Proposal for Supplement 3 to the 08 series of amendments to UN Regulation No. 107 (M₂ and M₃ vehicles)

Submitted by the experts from the Working Party on General Safety*

Supplement 3 to the 08 series of amendments to UN Regulation No. 107 (M₂ and M₃ vehicles)

"Figure 31

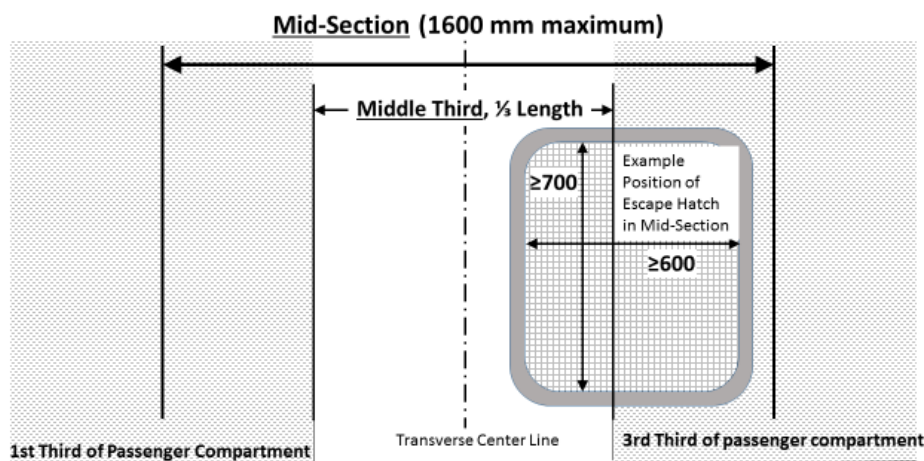
- "7.6.2.9. For vehicles of classes A and B, required escape hatches shall be positioned as follows:
- If there is only one hatch, it shall be situated in the middle third of the passenger compartment. As an alternative, on vehicles with a very short passenger compartment length, the hatch may be located in the mid-section of this compartment, and this mid-section shall be equally spaced longitudinally each side of the transverse centre line of the passenger compartment, with a length of no greater than 1.6m as shown in Annex 4, Figure 31;
 - If there are two hatches, they shall be separated by a distance of at least 2 m measured between the nearest edges of the apertures in a line parallel to the longitudinal axis of the vehicle."

Annex 4, after Figure 30 insert:

Alternative placement of escape hatch for very short passenger compartment length having a middle third smaller than 1600 mm

(See Annex 3, paragraph 7.6.2.9.)
